Massachusetts Institute of Technology
Instrumentation Laboratory
Cambridge, Massachusetts

LUMINARY Memo #121

To: Distribution
From: B. McCoy
Date: 5 November 1969
Subject: What Is LUMINARY 1C

Now that 1C is out the door, maybe a discussion is needed to describe what 1C contains and some details on the fixes. The released revision number is 130.

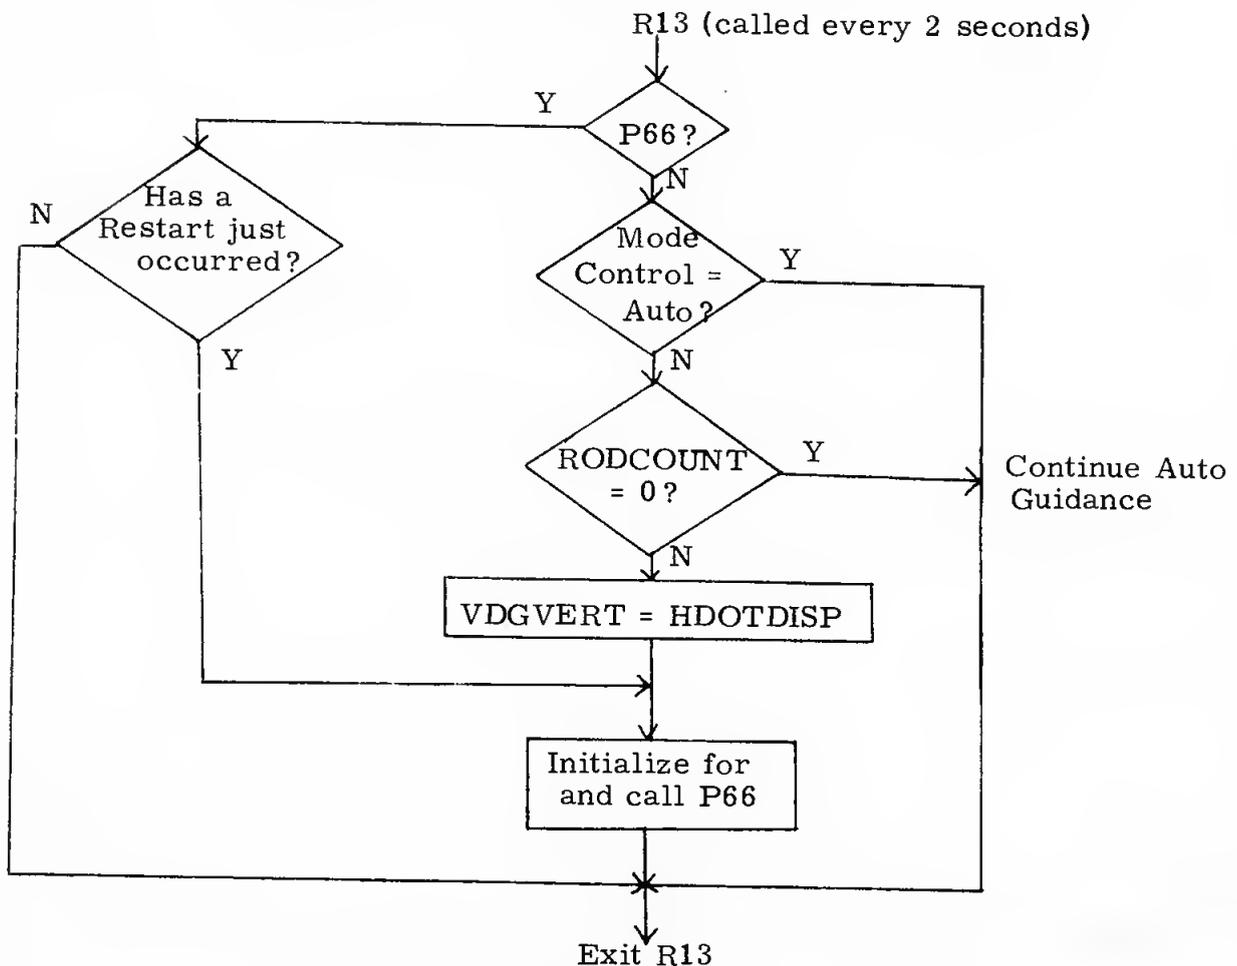
75 - There was a 50% chance of R04 not cycling from the RR sample logic to the LR sample logic. The decision to go into the LR logic was based on the contents of RTSTDEX; now the decision is based on RTSTBASE in subroutine R04Y.

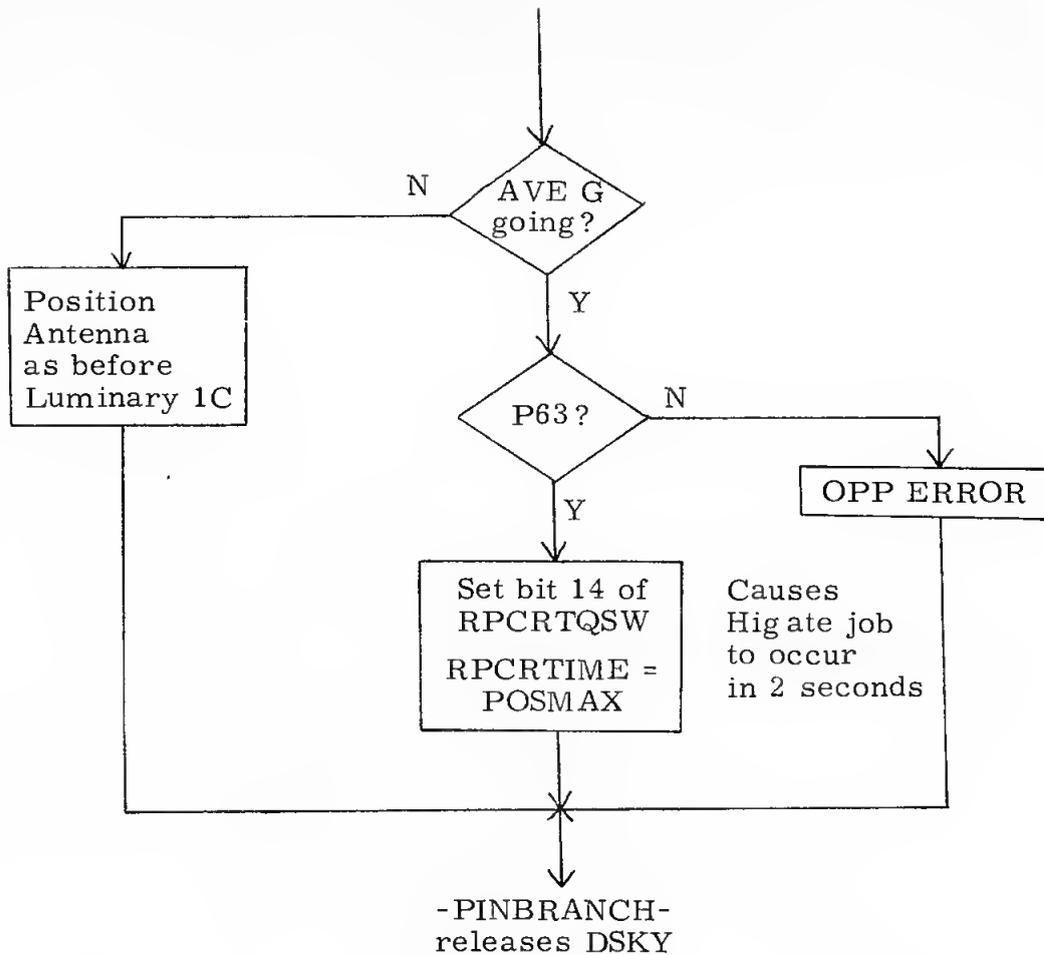
895 Extended Verb 59 is designed to move the Landing Radar antenna from position 1 to position 2. Before LUMINARY 1C this was not allowed during PDI. The flow below shows the addition to the V59 logic.
